# The Town of Hilton Head Island Regular Design Review Board Meeting

Tuesday, September 28, 2010

PROJECT	Hilton Head Brewing Company	DRB#	DR100036				
DATE	9/28/2010	RECOMMEND APPROVE	<input type="checkbox"/>	RECOMMEND APPROVE W/COND.	<input checked="" type="checkbox"/>	RECOMMEND DENY	<input type="checkbox"/>

WEST ELEVATION

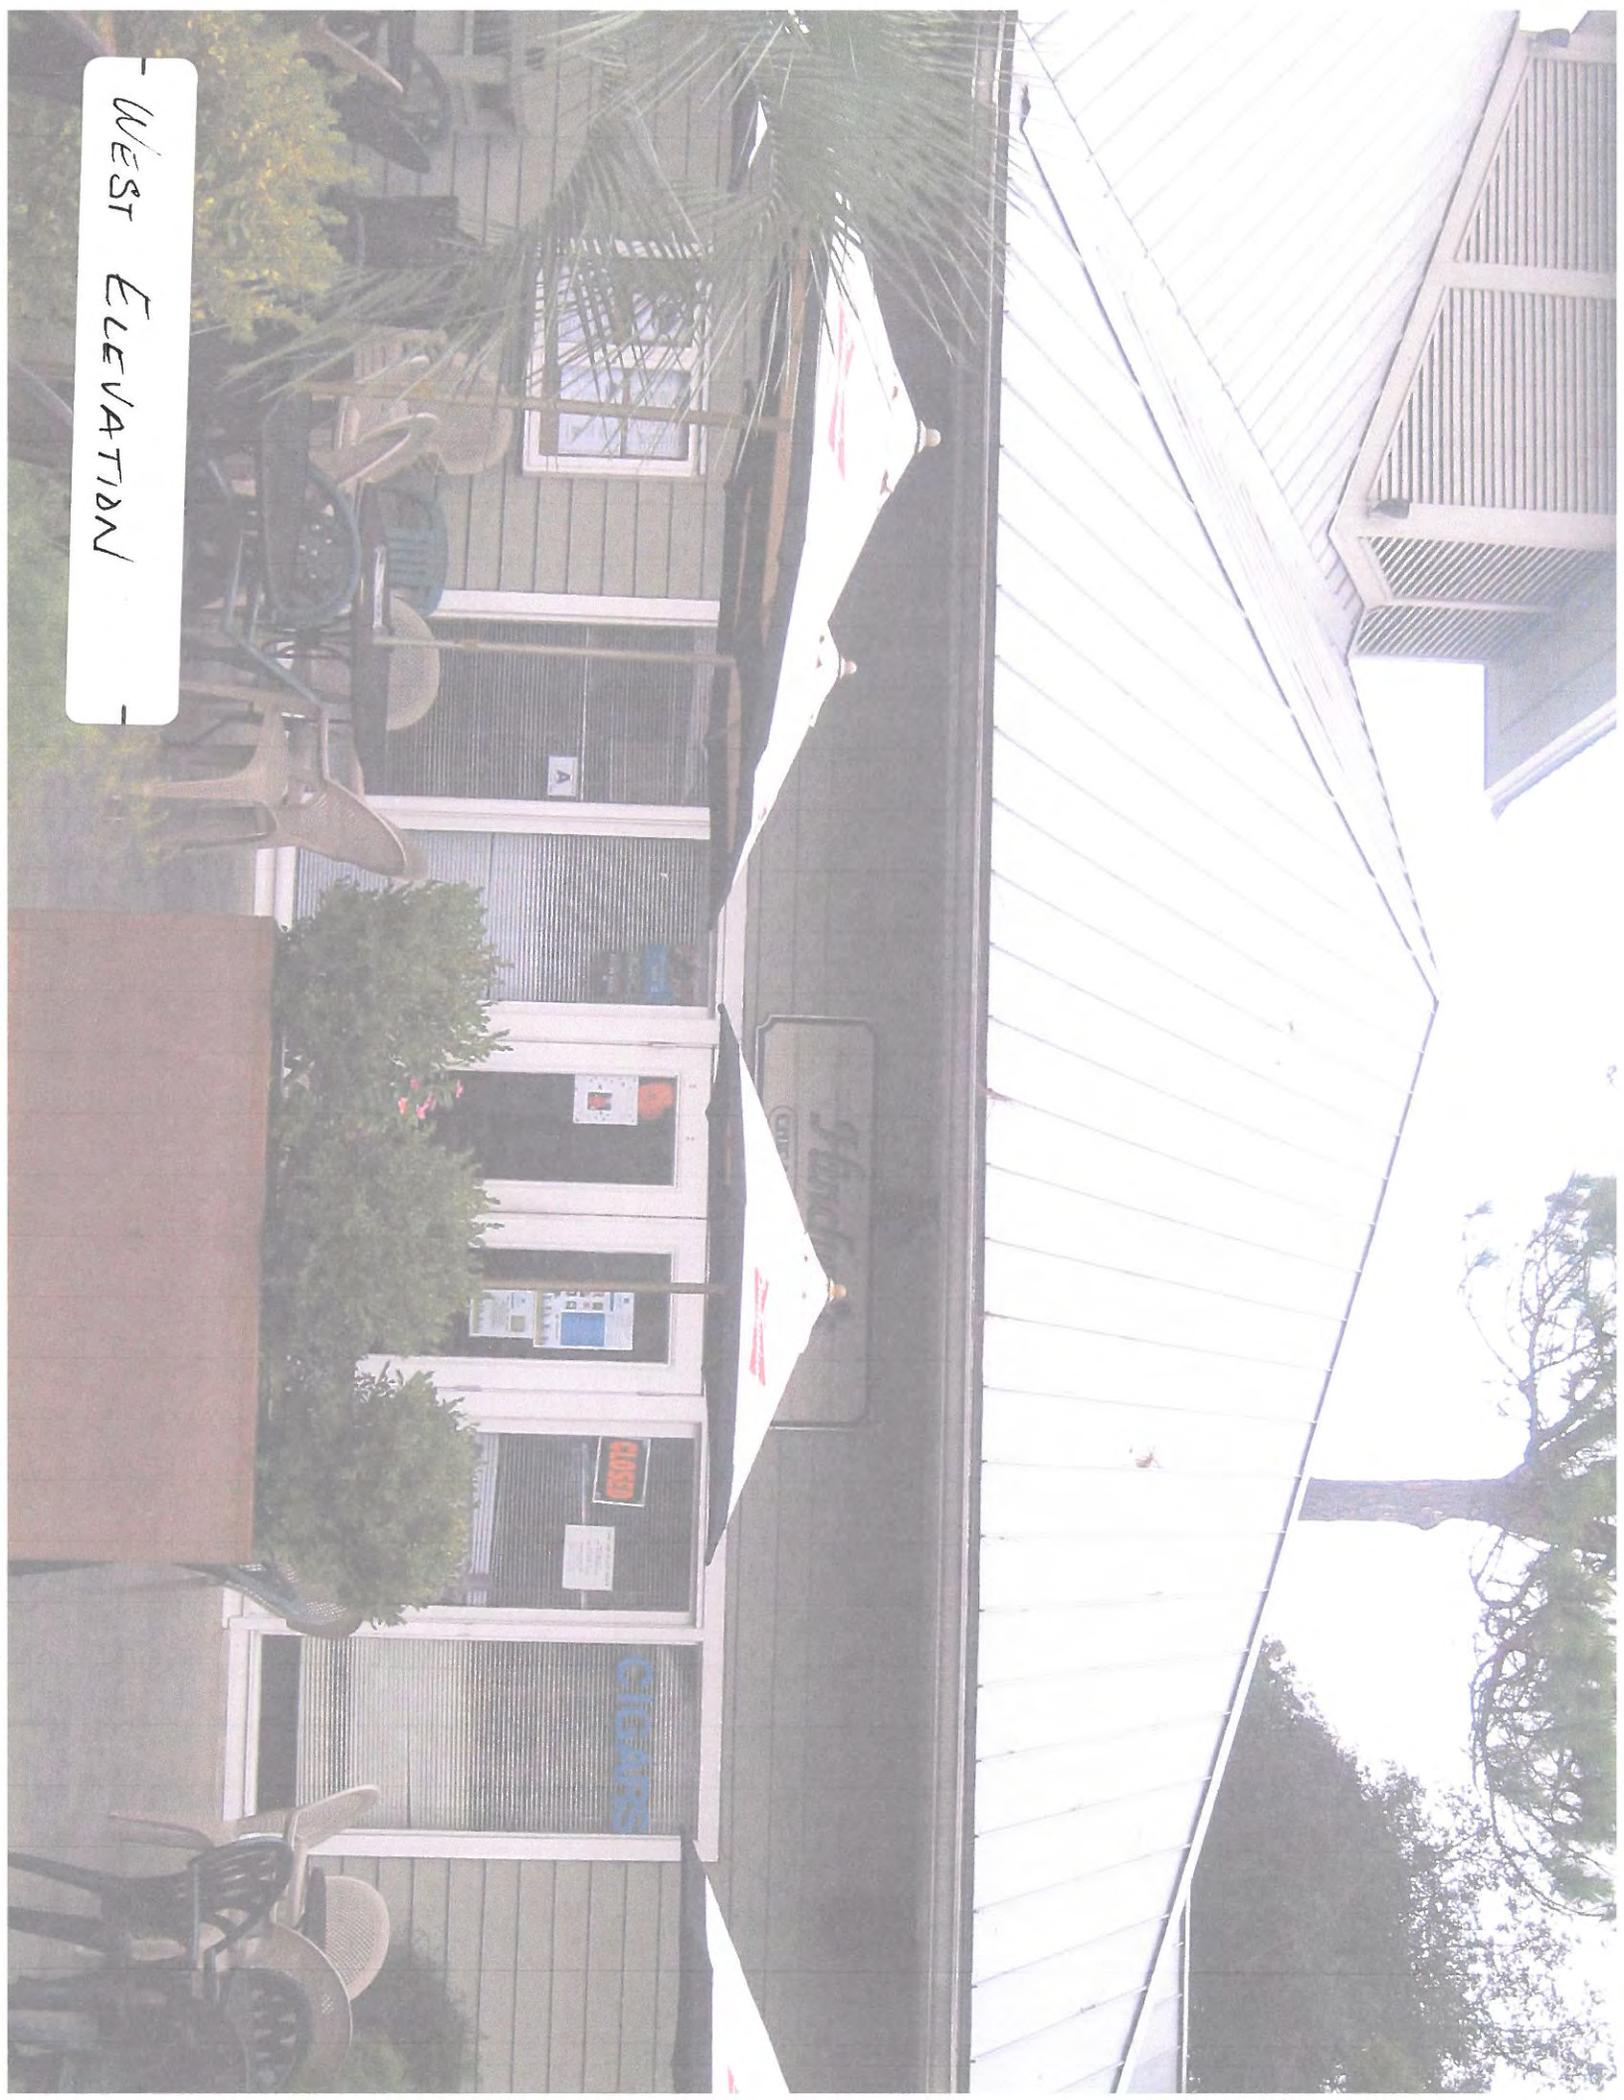
The Board discussed the colors, the windows, the awnings, the shutters, and door style. The Board recommended that the west elevation be re-studied for additional aesthetics. The applicant for this project was not available at today's meeting for comments or questions. Based on today's discussion, Chairman Parker recommended that the application be withdrawn for additional study. The staff **withdrew** the application on behalf of the applicant.

Applicant feels strongly about the 4-pane window configurations and awning for the West elevation, and has provided three options for the Board's review. Applicant will be at the meeting to discuss alternatives.
